**2021 CMOM Package 7
Solicitation Number: CO-00685
Job No.: 22-4516**

**ADDENDUM 2
October 24, 2023**

SUBMITTED	
APPROVED	
MAP No. 000-000	SHEET 116
SECT. No.	
DR:UOP CK:MML JOB No. 22-4516	OF 145

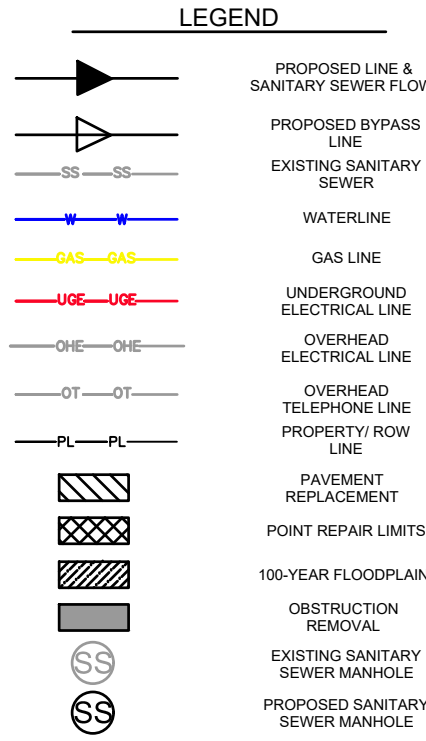
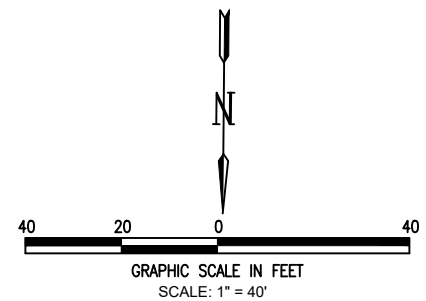
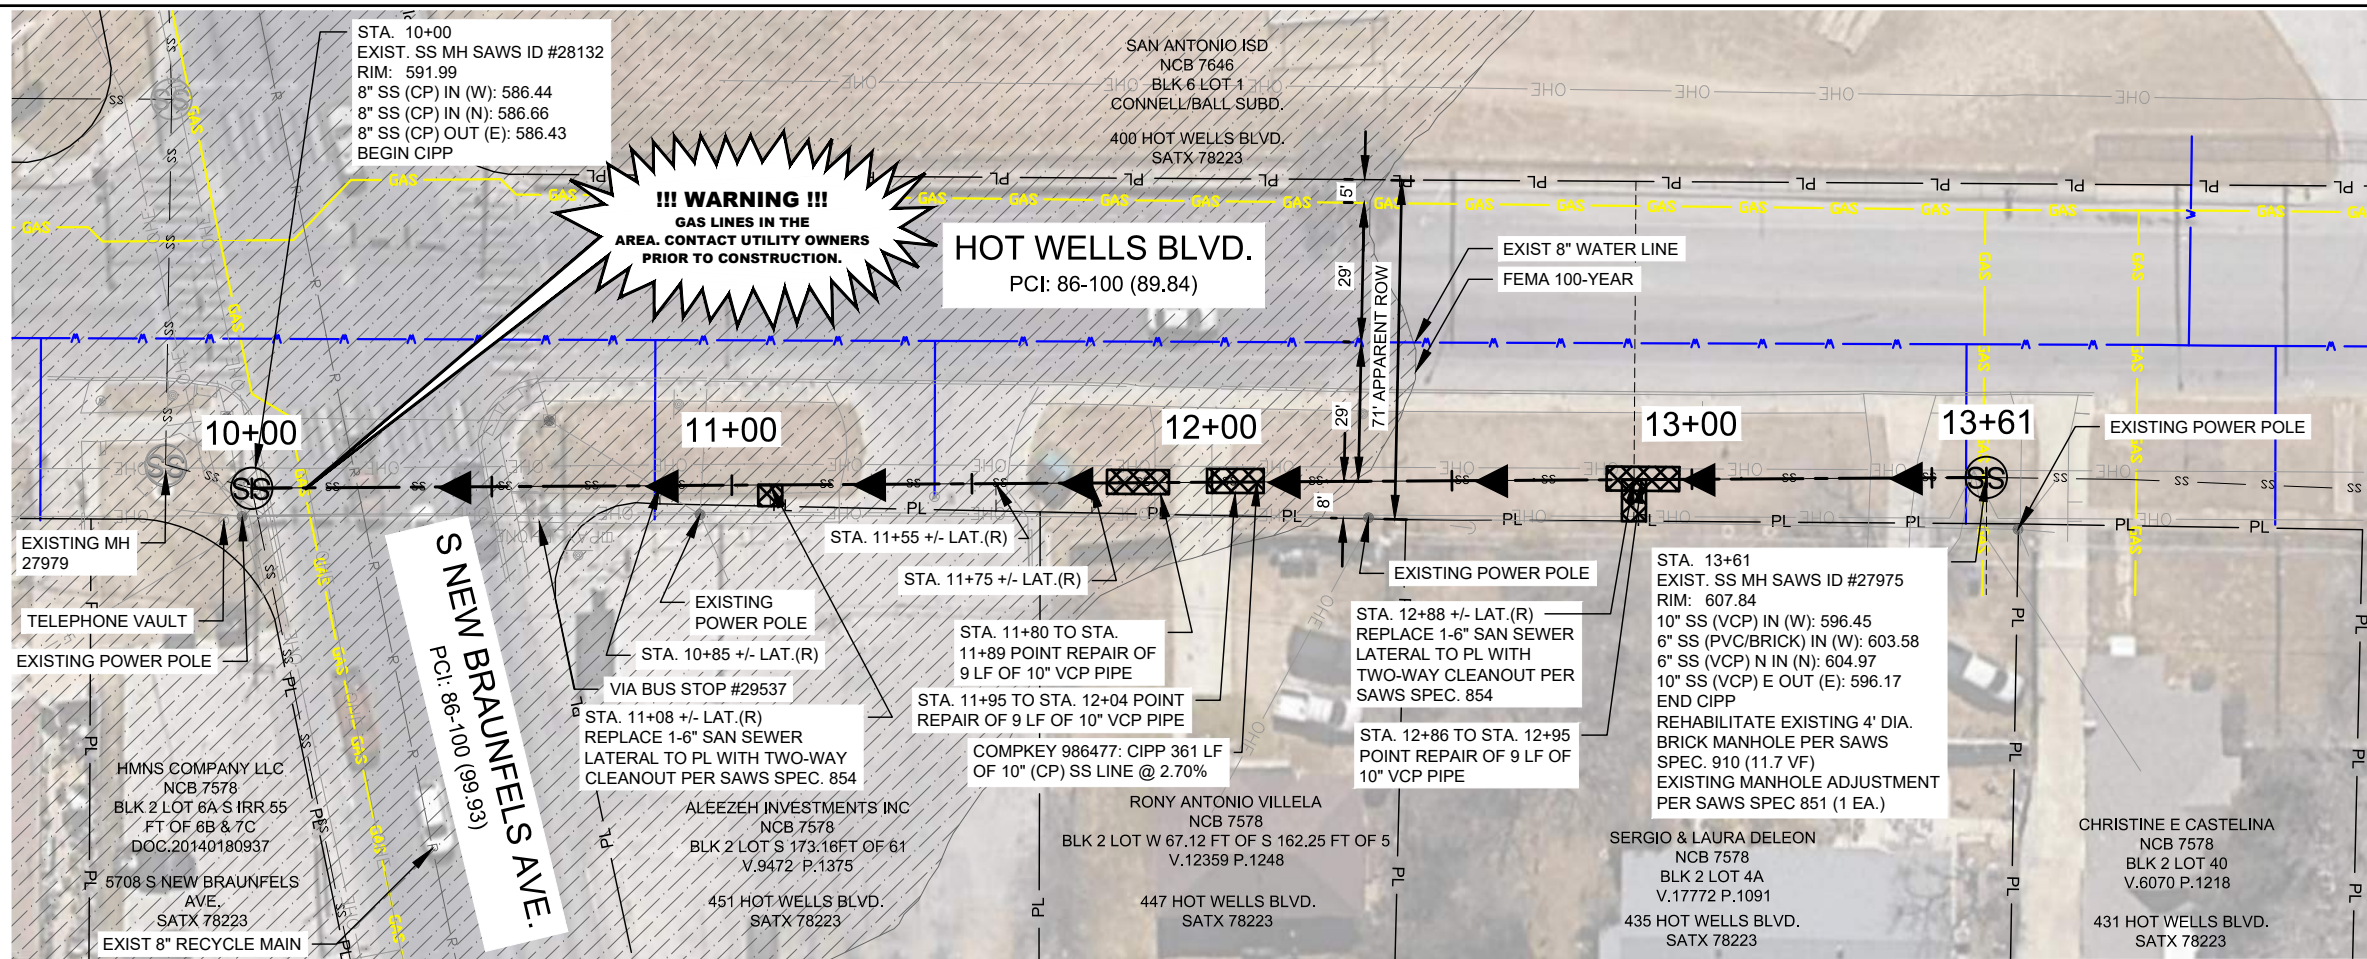
- o. Sheet 116 SITE 33 CMPKY 987364, 996370 STA 10+00 - 15+00 CIPP RHB
 - The note "SAWS IS IN THE PROCESS OF OBTAINING A PHASE II ESA REPORT FOR THIS SITE. REFER TO CONTRACT DOCUMENTS SC10" was removed.
